L-2016-107
10 CFR 50.12
10 CFR 52.63

Re: Florida Power & Light Company
Proposed Turkey Point Units 6 and 7
Docket Nos. 52-040 and 52-041
Endorsement of Supplement 2 to Voluntary Submittal of Exemption Request and
Design Change Description for Departure from AP1000 DCD Revision 19 to
Address Containment Condensate Return Cooling Design

Florida Power & Light Company (FPL) hereby submits its request for exemption and associated design change description to address a design change to the AP1000 Design Control Document (DCD) Revision 19. The design change requires Nuclear Regulatory Commission (NRC) notification and review in accordance with Interim Staff Guidance DC/COL-ISG-011, "Finalizing Licensing-Basis Information." The Turkey Point Units 6 and 7 Combined License Application (COLA) incorporates the AP1000 DCD by reference.

Figure 1: Containment Pressure Comparison

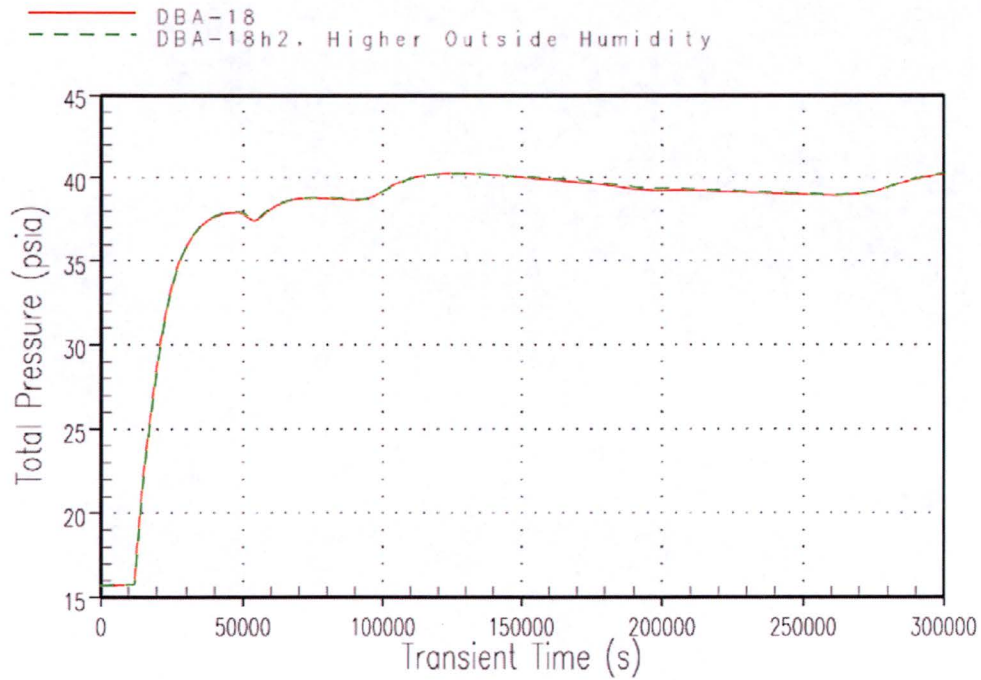
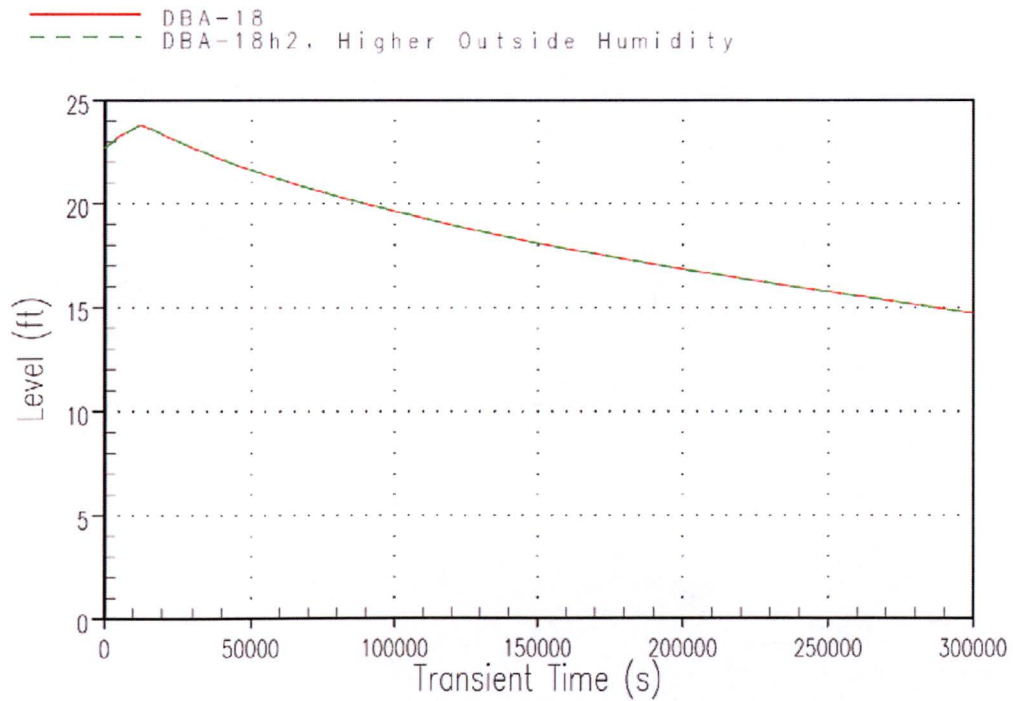
pressure (Figure 1) and IRWST level (Figure 2) for the DBA condensate return-related containment pressure analysis. Safety goals and margins are not challenged and all Chapter 15 acceptance criteria are met. Therefore, the AP1000 DBA extension evaluation and safe shutdown temperature evaluation are not adversely affected by the increase in environmental humidity (Reference 3, Section D.5.5).
